**WESTLAKE PLANNING COMMISSION
MINUTES OF THE WORK SESSION MEETING
JANUARY 14, 2019**

**Parkway Crossings, Development Plan (146 units),
Westchester Parkway, PP#213-03-001 & 003, rep. J.
O'Connor, Ward 3**

Development Plan (144 units), Westchester Parkway,
PP#213-03-001 & 003, rep. J. O'Connor, Ward 3, *tabled*
11/19/18, 1/7/19

Similar Sidewalk/Emergency Access at Crocker Woods Cluster

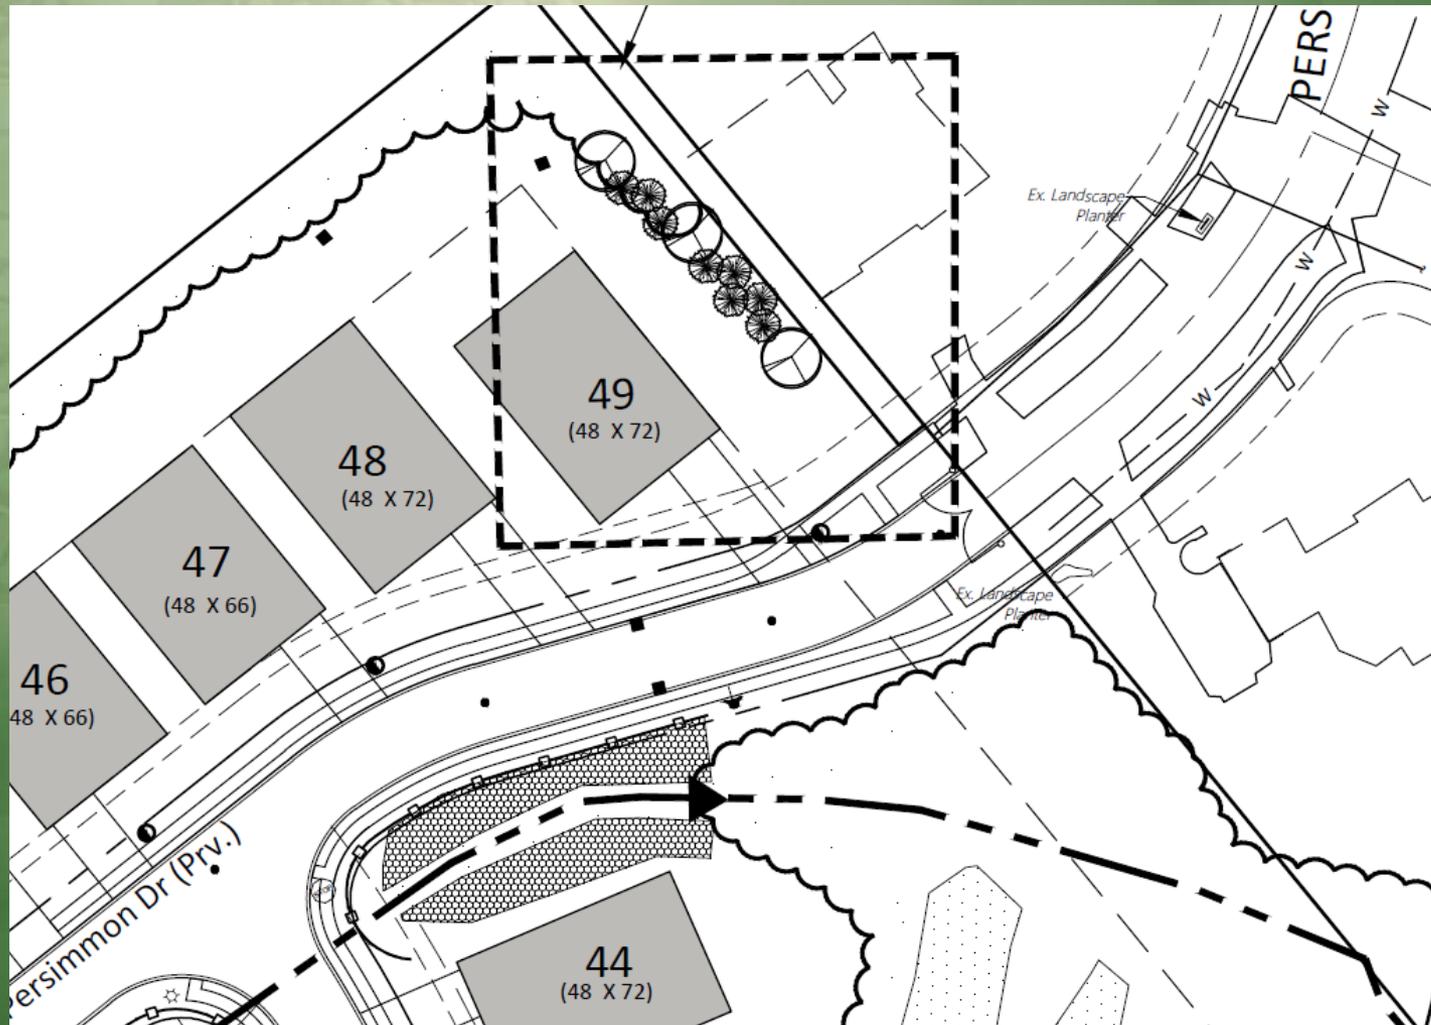
- Mr. Bedell suggested that options be provided for the February meeting with an option showing the sidewalk and a second one showing it as a possible future sidewalk. A third option is no sidewalk. He showed a recent example (Crocker Woods Cluster) that has an emergency access connection and sidewalk connection to a long-established subdivision. A resident noted the difference being that the sidewalk in question connects Bryandale and Westchester Parkway with little reason to use it versus the Crocker Woods example that connects residents of Bretton Woods to Crocker Road and the Bradley Woods Reservation.
